Reference: 2026-004M

URGENT - FIELD SAFETY NOTICE

To all users of **Olympus Single Use Ligating Device**

Re: Olympus to Provide Update on Instruction For Use (IFU).

Figure 1

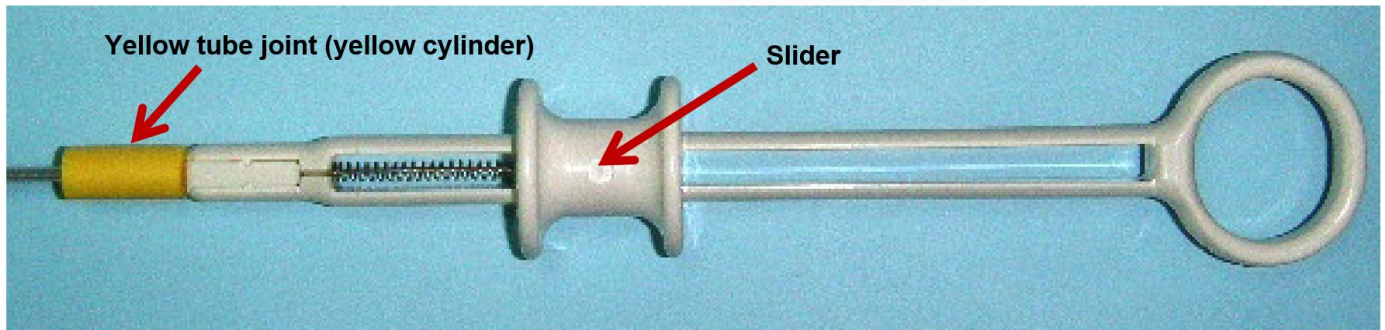
- Inadvertent or intentional movement of the yellow tube joint (cylinder) away from the device handle during use. Intentionally moving the yellow tube joint away from the handle to prematurely tighten the loop during use may cause the inability to release the ligation loop. (See figure 1 below.)
- Forceful advancement of the slider located on the device handle when resistance is encountered may cause an inability to release the loop.

■ Do not hold the loop with the distal end of the tube sheath while the loop is surrounding the tissue. (refer to page 5 in the manual)

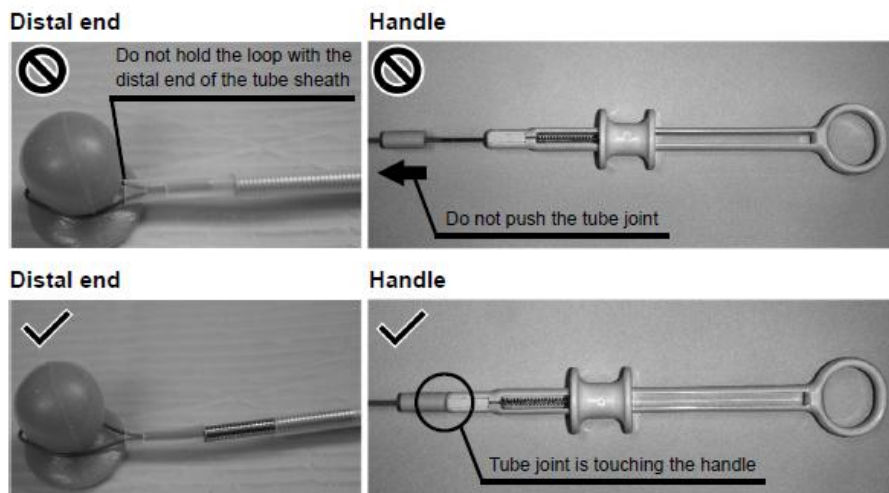
Otherwise, when the tissue is ligated, the loop may be detached from the hook in the tube sheath and tangled with the hook.

- **Do not remove the loop from the hook while the coil sheath is not extended from the tube sheath. (refer to page 6 in the manual)**

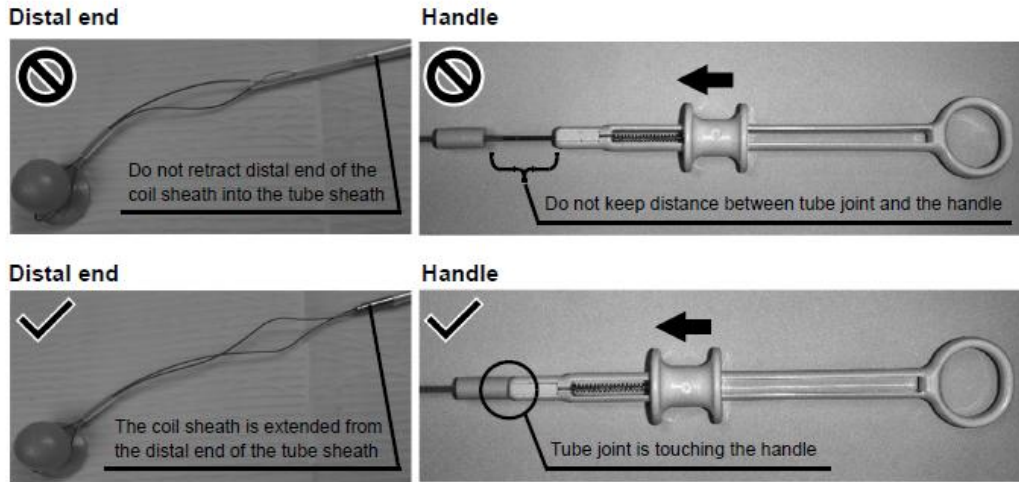
Otherwise, the loop may be tangled with the hook and become impossible to be removed.

- **With the proximal end of the tube sheath and handle kept straight against the biopsy valve of the endoscope, push the slider when detaching the loop. (refer to page 6 in the manual)**

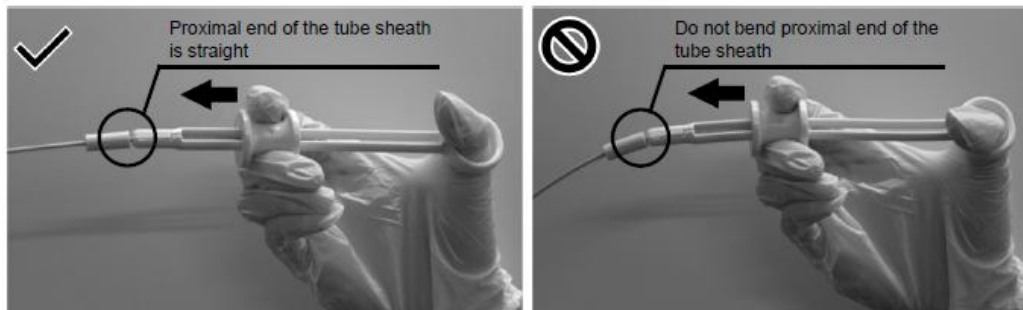
Bending the proximal end of the tube sheath will increase frictional resistance, which may damage the handle when pushing the slider.
